SAN LUIS COASTAL
UNIFIED SCHOOL DISTRICT

Bid #336 C.L. Smith Phase 2 Modernization Project
Addendum No. 02 dated April 8, 2026

C.L. Smith Modernization Phase 2

Addendum A

PROJECT MANAGER: RAG
DRAWN BY: KC | CHECKED BY:
DATE: DECEMBER 12, 2025
PROJECT NUMBER: 0100-06-ED24
SHEET: C-2.1

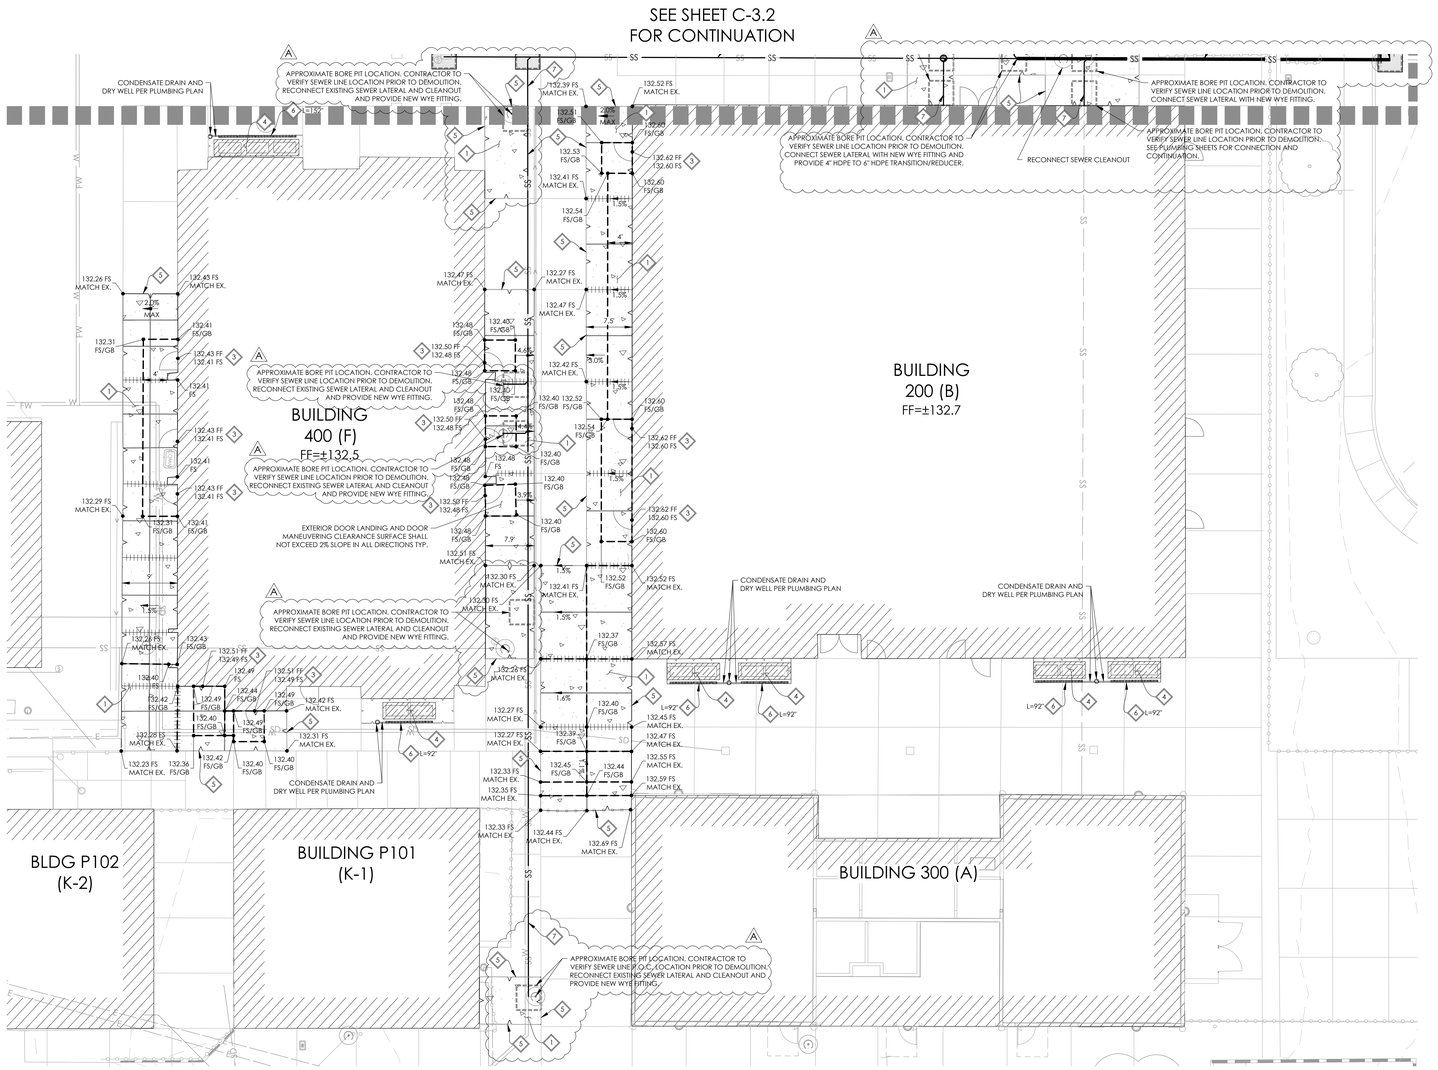
1. **Sheet C-2.1**
   - a. Added extents asphalt and concrete flatwork removal for trenchless sewer upgrades.
2. **Sheets C-3.1, C-3.2, C-3.3**
   - a. Updated sheet to show approximate bore locations for trenchless sewer upgrades.
3. **Sheet C-8.1**
   - a. Updated erosion control measures for added scope for trenchless sewer upgrades.

SHEET
A2-111

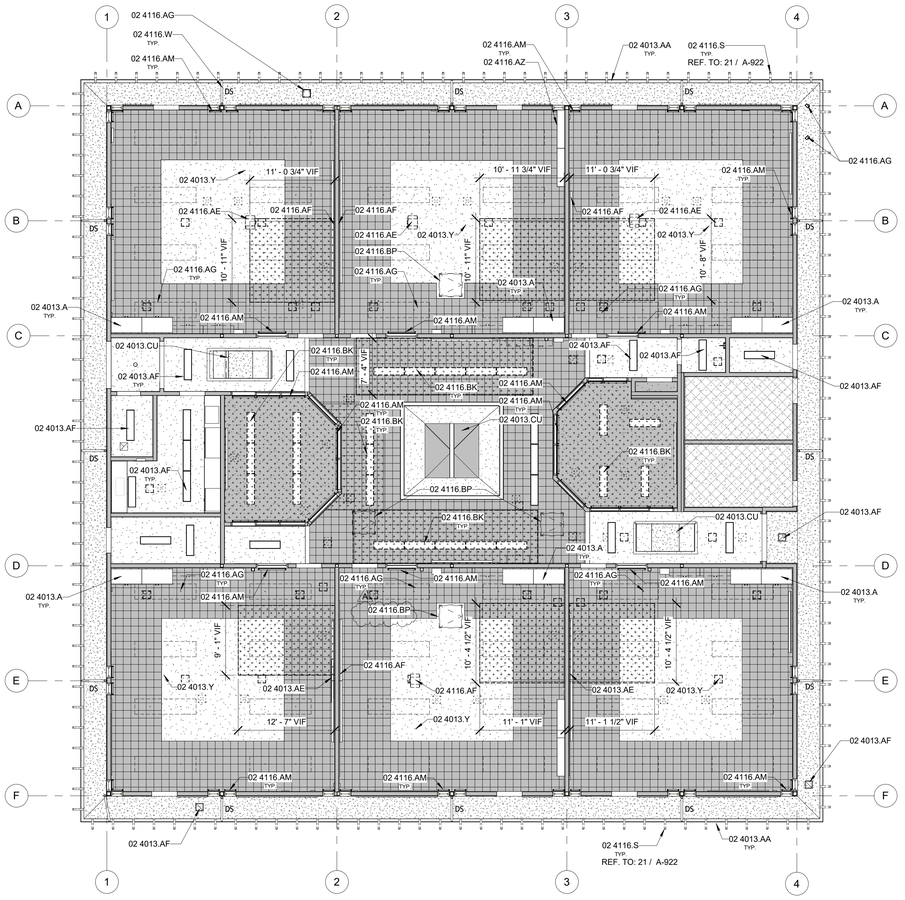
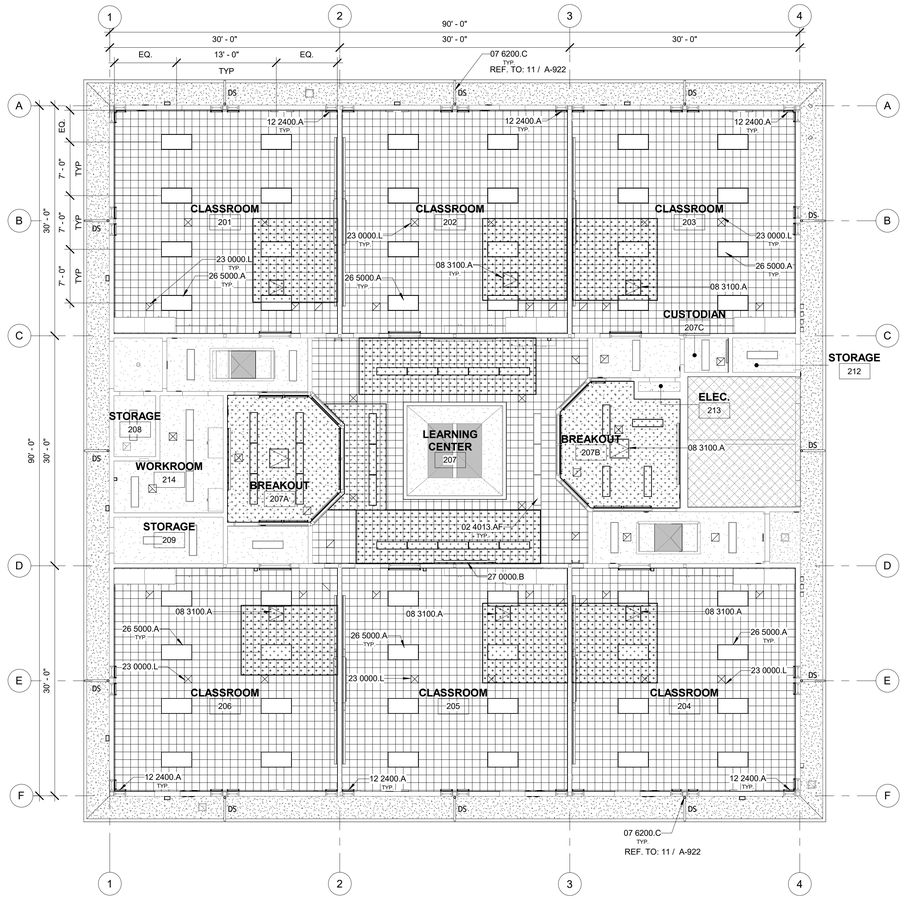
1. **Sheet A4-101, A5-101**
   - **a.** Updated demolition notes to clarify that all doors need to be protected in place unless otherwise noted.
2. **Sheet A2-111, A5-111, A7-111**
   - **a.** Updated ceiling access panel demolition keynotes.
3. **Sheet A6-102, A6-112, A6-400, A6-413, A-942**
   - **a.** Updated half wall to be full height non-bearing wall and associated lighting revisions.
4. **Sheet A6-131**
   - a. Updated flooring finish note for outdoor servery adjacent to kitchen to meet health department requirements.
5. **Sheet A2-411, A2-412, A2-413, A2-414, A2-415, A4-411, A4-412, A4-413, A6-411, A6-413, A6-414, A7-411, A7-412, A7-414**
   - **a.** Updates to teaching wall tv bracket and power/data locations per district standards.

PROJECT MANAGER
DRAWN BY: DM
CHECKED BY: RS
DATE: 12/12/2025
PROJECT NUMBER: 0100-06-ED24
SHEET: P-001

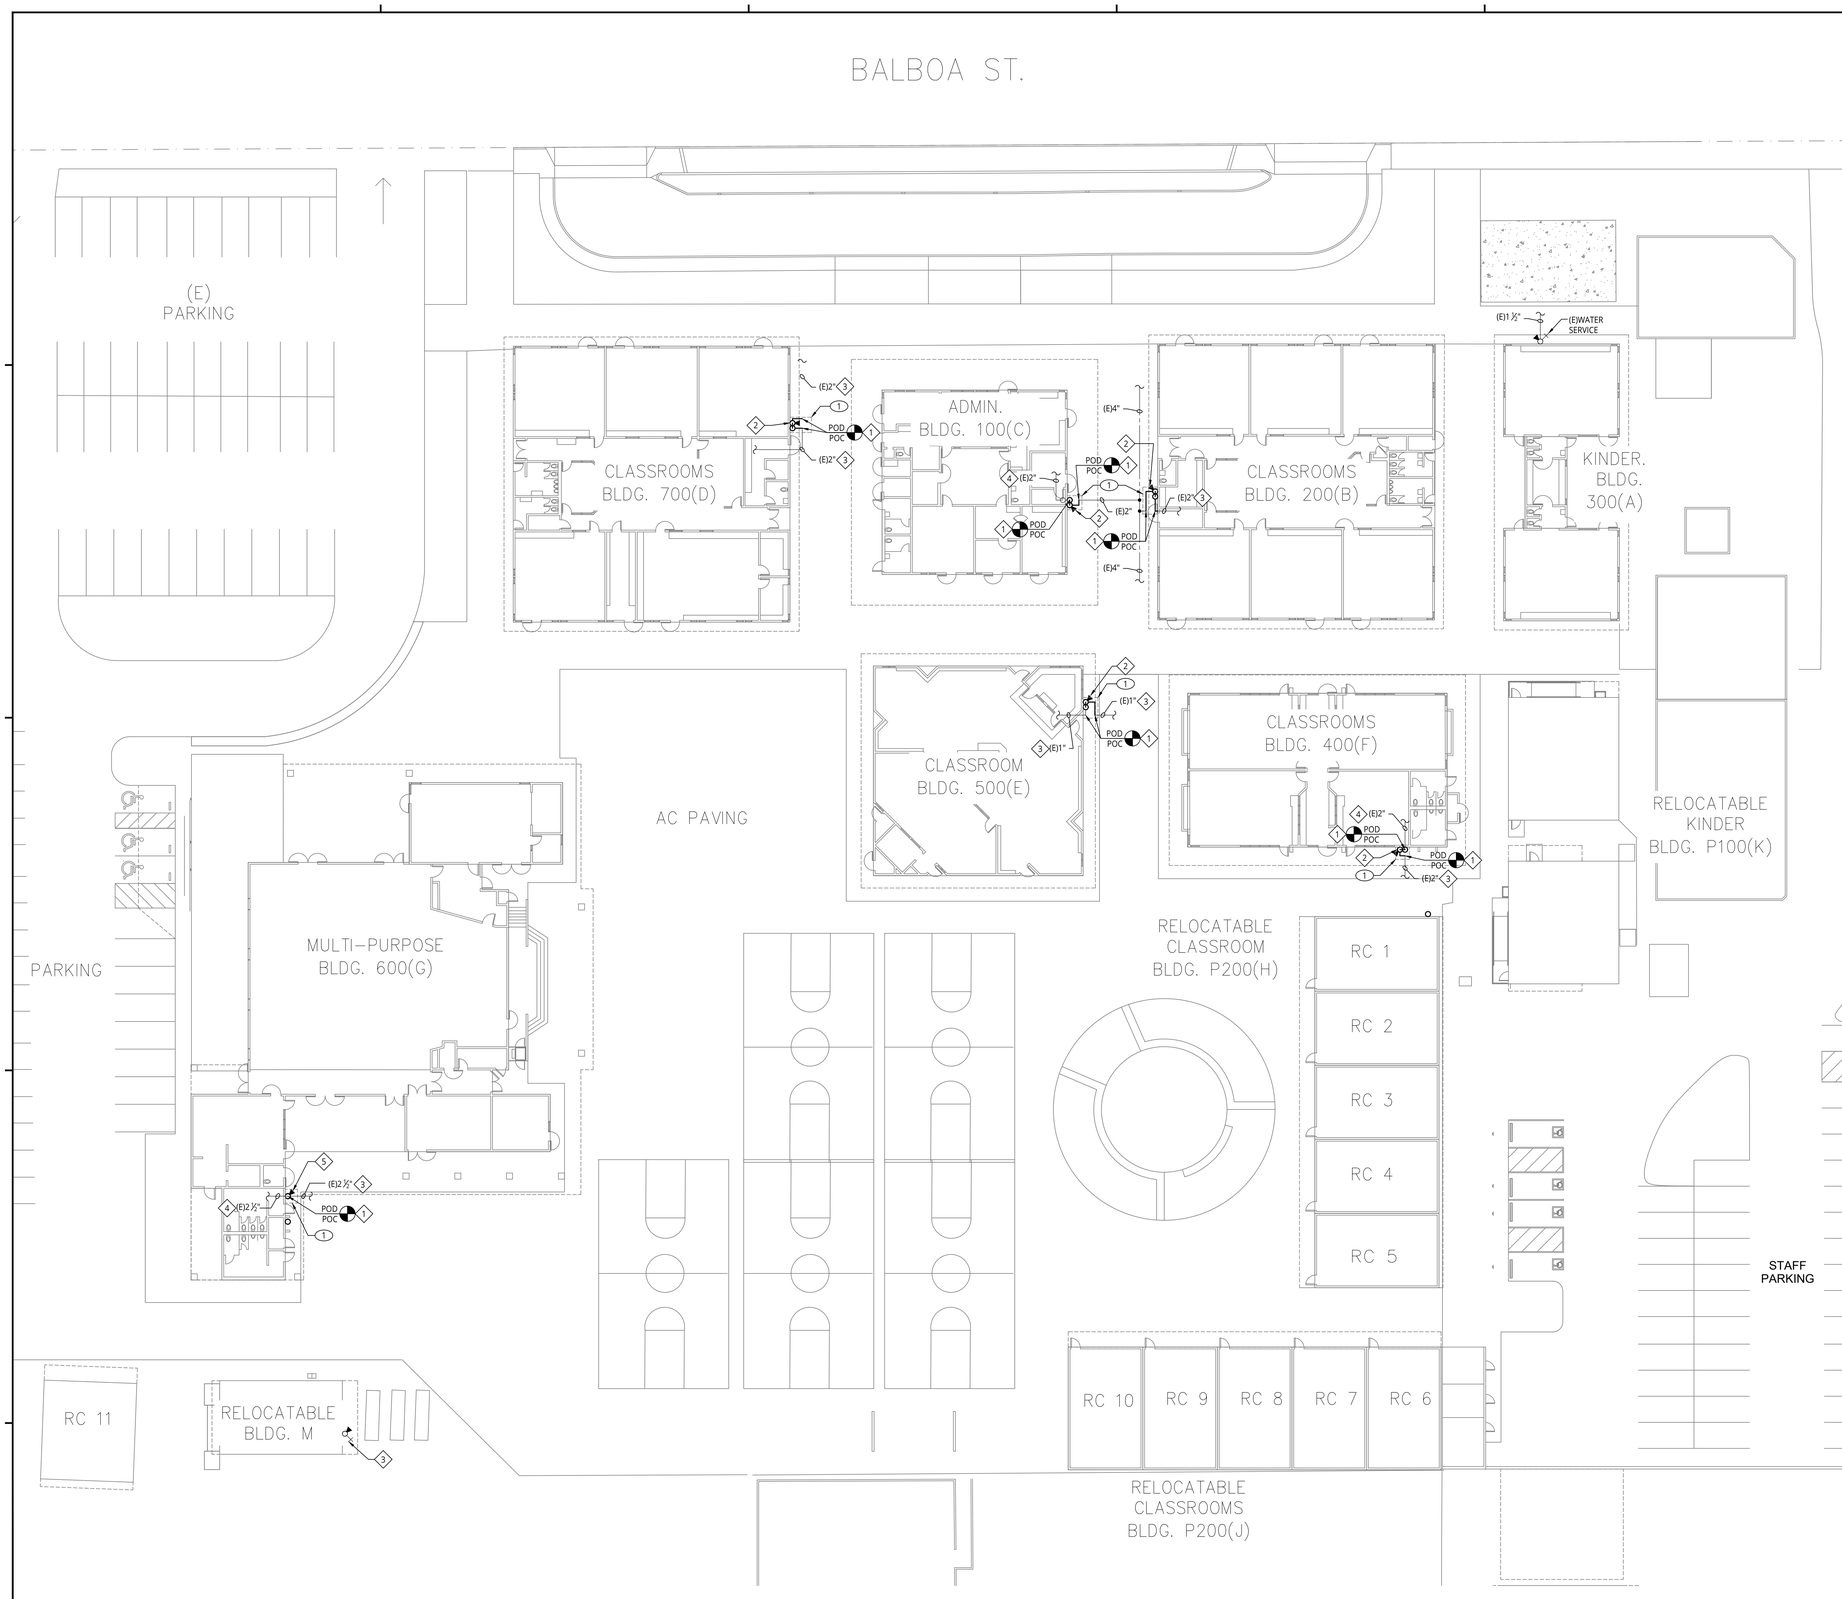
1. **Sheets P-001, P7-101**
   - a. Updated plumbing fixture schedule to include fixtures in Restroom 709B
   - b. Updated plans.
2. **Sheet P-002**
   - a. Added above ground water shut off scope at each building

SHEET
P7-102
A

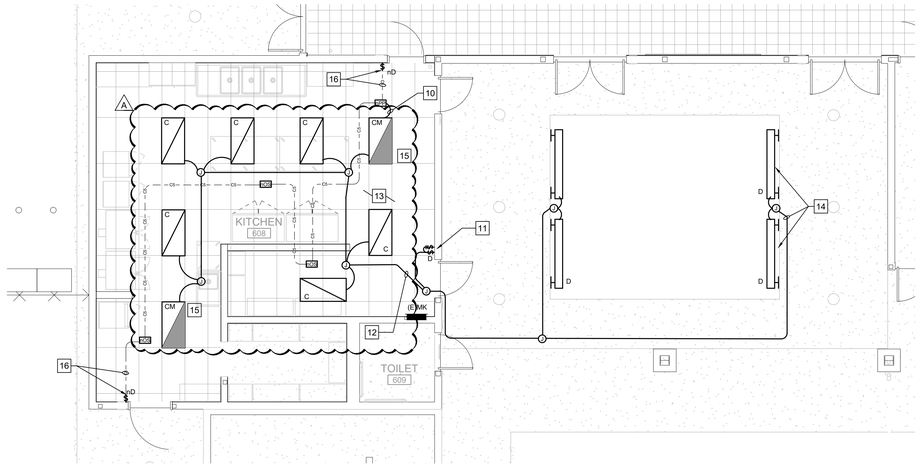
3. **Sheets P2-102, P7-102**
    a. Added trenchless sewer pipe replacement under building 400 and 700.

1 BUILDING 600 - ENLARGED LIGHTING PLAN AT KITCHEN/SERVERY

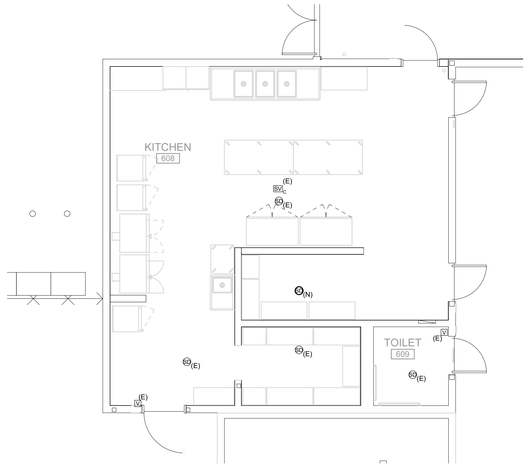
- **Select Electrical Sheets – Reissued sheets with clouded revisions**
  1. **Sheet E6-104**
      a. Updated sheet to show revised lighting in kitchen due to full height wall.
